ECOS
ENVIRONMENTAL
♦ COUNCIL ♦
OF SACRAMENTO

November 14, 2025

Re: Airport South Industrial Project Annexation, Entitlements and Final EIR; Agenda of Nov 18 and Dec 2, 2025

Figure 1. Accumulation of wildlife species detections at a Sacramento-area site over 41 surveys, ending at 149 species. However, the pattern in the data indicates via modeling that 191 species would eventually be detected after additional surveys.

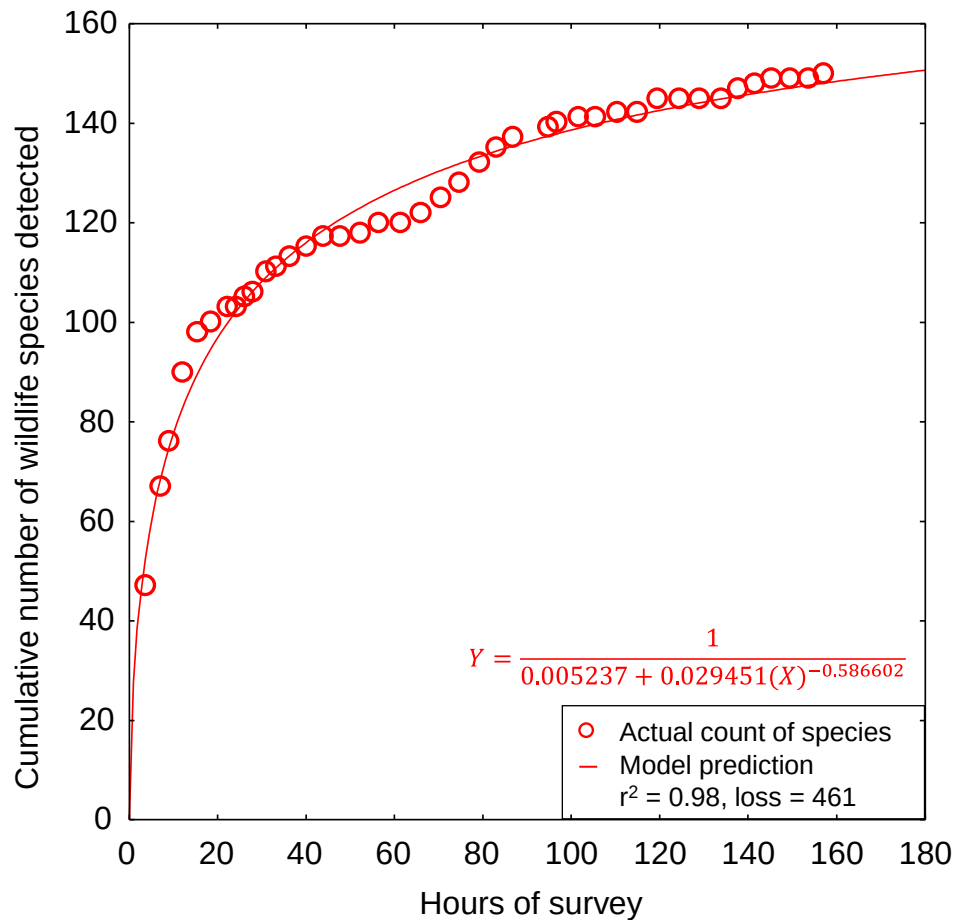
The response alleges my model (1) overstates the number of species that occur on the site due to bias, and (2) infers few species were detected each survey. It is unclear to which model the response refers, it provides no evidence of the alleged bias, and it neglects to explain how the bias came about. On these points, the response asserts empty accusations of bias and misdirected inference.

It is unclear which model the response alleges to be biased, considering that the response spans my comments addressing three models, the first depicted in Figure 1, the second depicted in the text on page 18, and the third depicted in Figure 2 of my 16 July 2024 comment letter. Even less clear is that portion of the response that claims my model infers “few species were detected each survey.” My final point on this lack of clarity is that it is not the model that draws inferences, but rather the analyst making use of the model. I fail to understand the point of the response regarding inference pertaining to bias and surveys.

Figure 2. The probability of detection of white-tailed kite at a given site within its geographic range in California is a function of both survey duration and proximity of occurrence records in eBird.

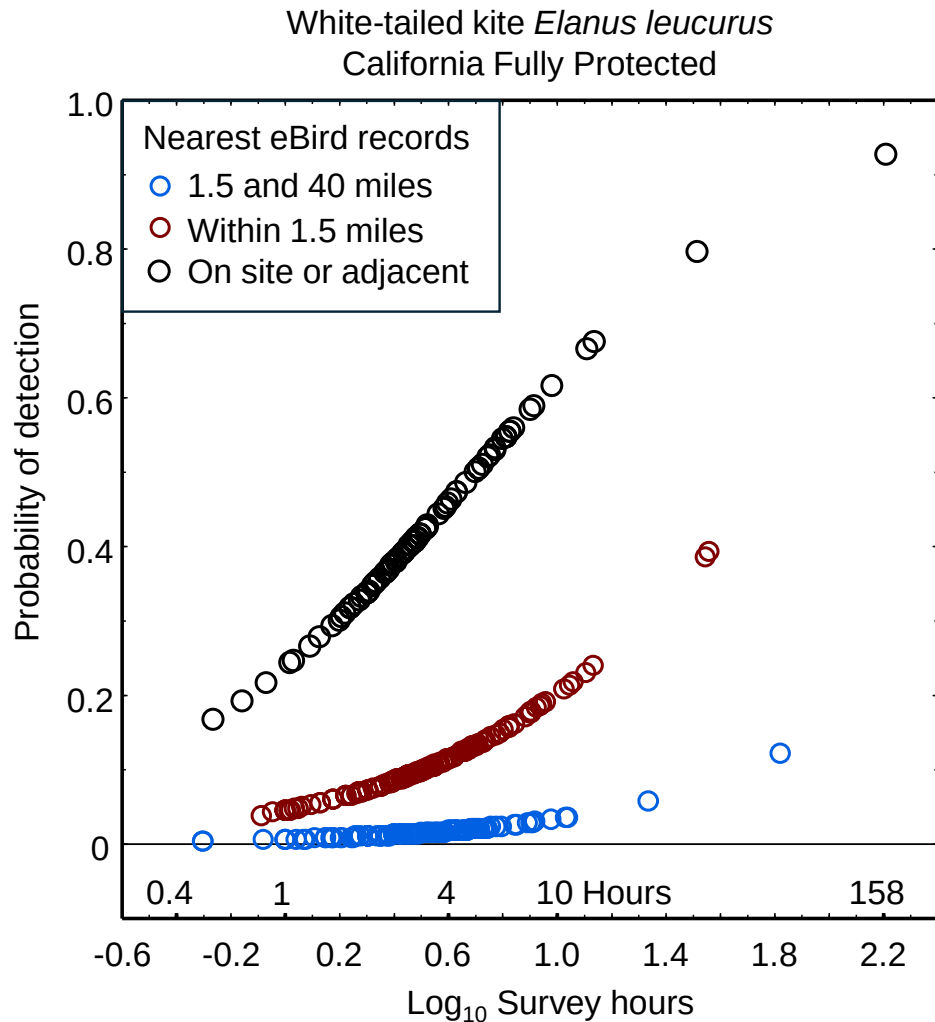
Reply: The response is inaccurate because it is looking at our proximity domains (within 1.5 miles, between 1.5 and 4 miles, and between 4 and 30 miles in the case of my letter of 16 July 2024) in the wrong way. The proximities of occurrence records serve as a useful predictor of the likelihood of detection of a species on a given site (Figure 2). As shown in this case for white-tailed kite, occurrence records that are more distant from a site decrease the likelihood of detection at a given level of survey effort, but they do not

preclude detections altogether (consistent with the tenet that occurrence records should not lead to determinations of absence). More distant records more accurately inform of the need for greater survey effort to detect the species on the site. In the example of the white-tailed kite, the addition of proximity domains informs us that to achieve a 10% likelihood of detection, even a brief survey should be all that is needed if the nearest occurrence record was on site or adjacent to the site, but four hours would be needed if the nearest record was within 1.5 of the site, and 10 hours would be needed if the nearest record was between 1.4 and 40 miles of the site.

Figure 3. eBird occurrence records (teardrop symbols, where red symbols identify

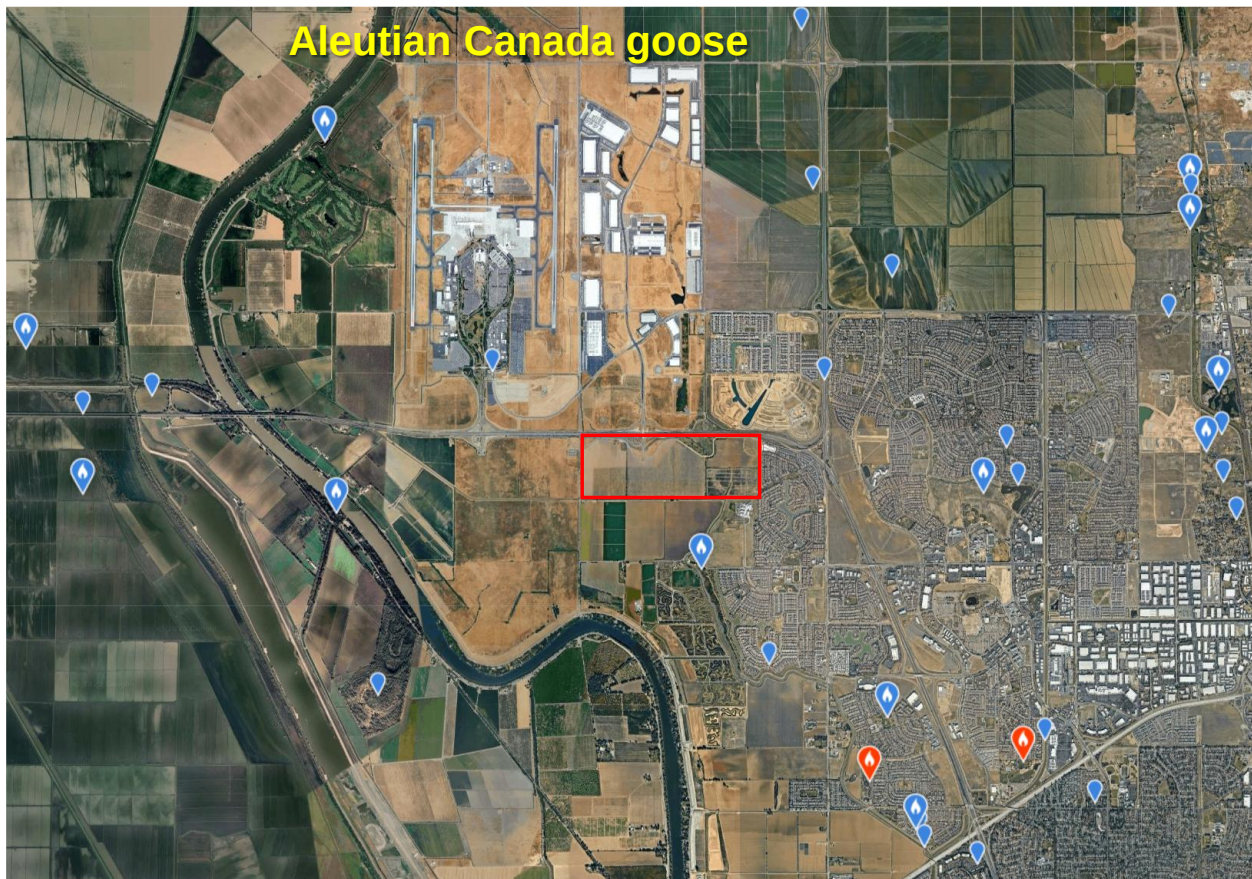
Reply: It is not true that the DEIR determines the Aleutian Canada goose and white-faced ibis are not expected to occur on the project site. The determination for both species is of low likelihood of occurrence. Bargas assigns its low occurrence likelihood to “Species with few known recent recorded occurrences/populations near the Biological Study Area and habitat within the Biological Study Area is highly disturbed or extremely limited.” A different standard is applied to species not expected to occur. This error of the response pointed out, I will add that I disagree even with the DEIR’s assignments of low occurrence likelihoods. I have seen Aleutian Canada goose and white-faced ibis all around the project site. Furthermore, there are many eBird occurrence records of both species around the project site (Figures 3 and 4), all of which add to the likelihoods that both species occur on the site (indeed, one record of white-faced ibis is on the site).

The addition of 86 acres of detention basins would increase the likelihoods of occurrences of these species on the project site, unless, that is, the Wildlife Hazard Management Plan would resort to extreme or even lethal measures to discourage them (more on this below).
